Bloomfield High School Exterior Door Replacement

ADDENDUM #1 Issued November 9, 2016

RESPONSE TO REQUEST FOR INFORMATION

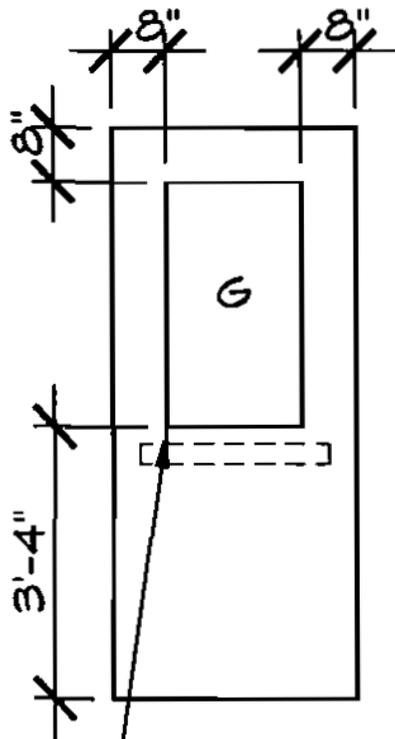
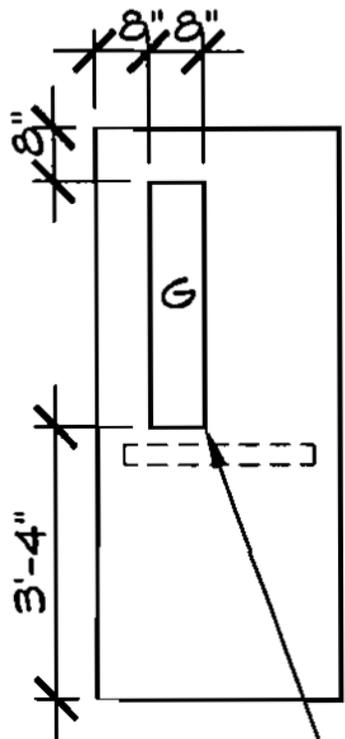
1. Do you have elevations of type 'C' and Type 'E' doors so the door size and required glass size if any can be determined?

A: Door elevations are attached as part of this addendum.
